ADDENDUM No. 1
BID #5700
City of Fort Collins and CSU Transit Center

Description of Bid #5700 City of Fort Collins and CSU Transit Center

To all prospective bidders under the specifications and contract documents described above, the following changes are hereby made.

SK-3
ALTERNATE #2 - LOADING DOCK AREA REVISION
DRAWN BY: JAL
CHECKED BY: JAL
DATE: 11/11/01

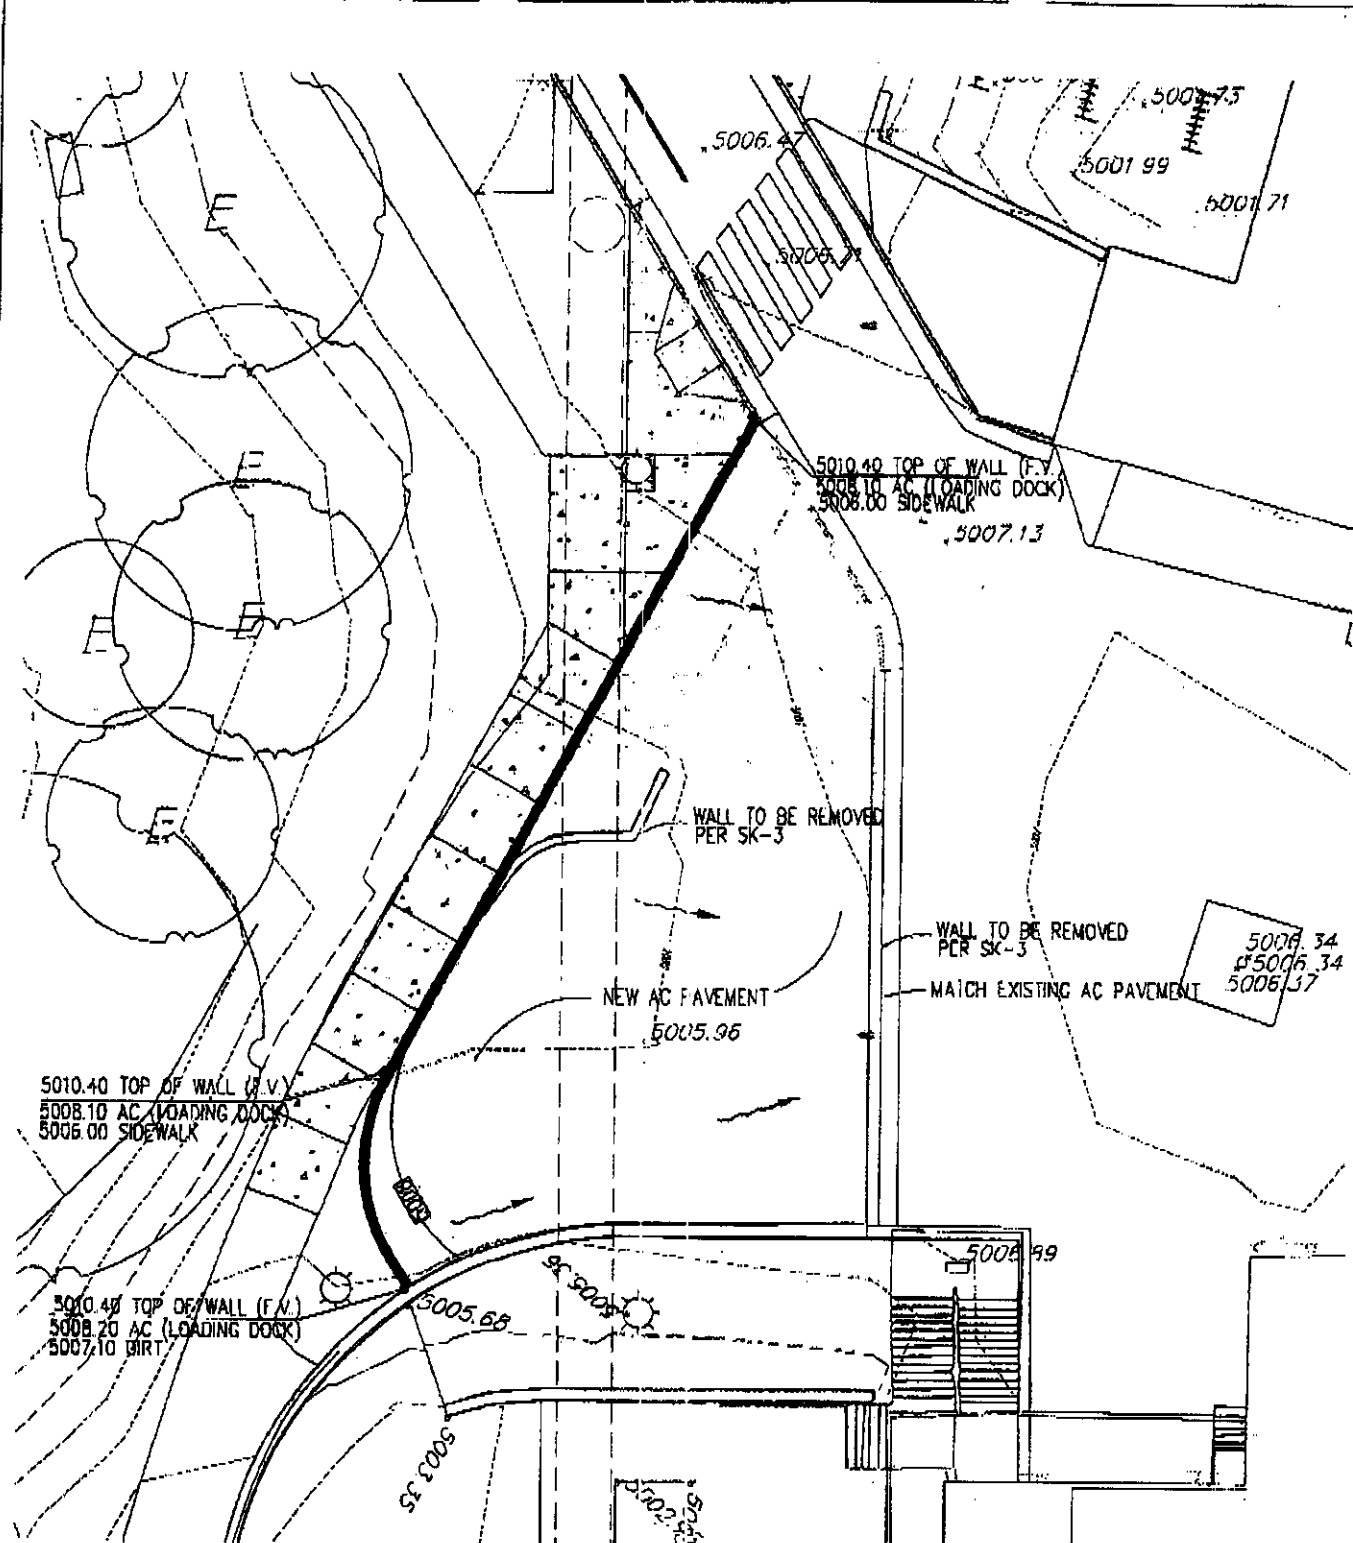
- iv. ROTATE each bike rack at area to west of Lory Student Center 90 degrees. Verify placement in field with Owner.
 - b. Drawing 3/A-1: See attached SK-3 for revised layout of new flood wall (alternate #2).

(E) CURB & BUTTER TO REMAIN, TYP.
(M) PAVEMENT STRIPING, RE. CIVIL, TYP.

(E) LIGHT POLE TO REMAIN, PROTECT DURING CONSTRUCTION, TYP.
(R) TREES TO REMAIN, PROTECT DURING CONSTRUCTION, TYP.

NEW CONC. SIDEWALK, RE. CIVIL, MATCH (E) SIDEWALK GRADE, TYP.
COVER (E) TUNNEL WITH 10 ML POLY MEMBRANE IN AREAS TO BE COVERED WITH FILL - WRAP EDGES 1'-0" F.V. EXACT LOCATION
(E) SIDEWALK TO REMAIN, PROTECT DURING CONSTRUCTION, TYP.

RE-DO ALL DISTURBED AREAS PER L-1, TYP.

NEW CURB & BUTTER, RE. CIVIL, TYP.
NEW MC RAMP, RE. CIVIL
DEMOL. EXIST. WALK TO NEAREST LIGHT TO RECEIVE NEW WALK, TYP.
DEMOL. (E) CURB & BUTTER, TYP.
NEW CONC. FLOOD WALL, RE. 304-1, TYP.

REMOVE & RELOCATE EXIST. TREES (10'-12" DBH CALIPER, ONE 3" DBH CALIPER) PER L-1

NEW DETERMINING ASPHALT PAVEMENT, RE. SPECS
REMOVE (E) FLOOD WALL & CURB, TYP.

(E) REMAINING WALL TO REMAIN, PROTECT DURING CONSTRUCTION, TYP.

1 SK-4 FLOOD WALL @ LOADING DOCK AREA - REVISED
3/4"=1'-0"

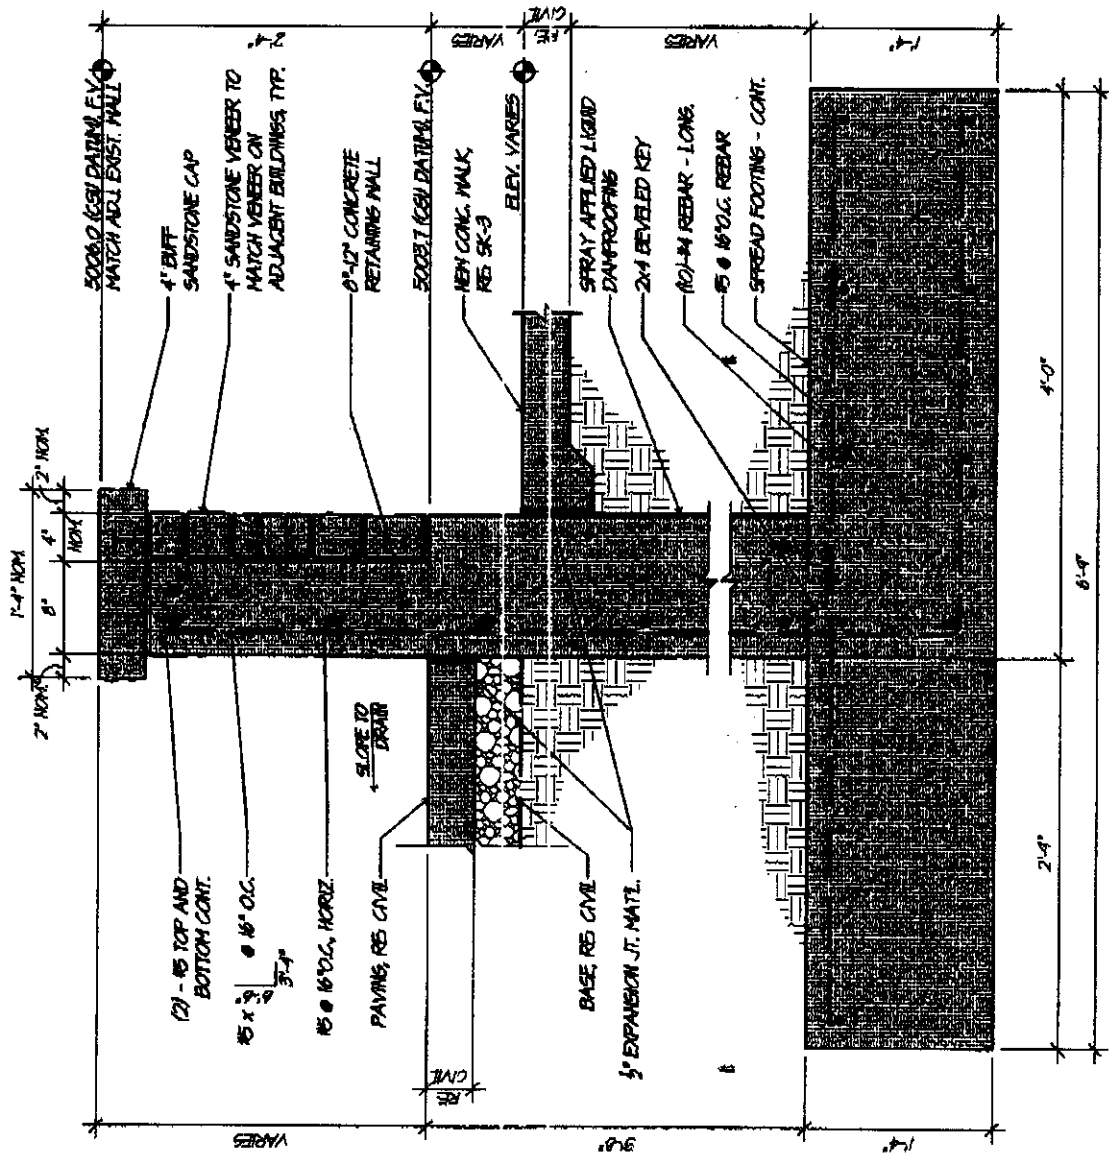
5. Sheet A-4:
 - a. REPLACE Drawing 7/A-4 with attached SK-4.
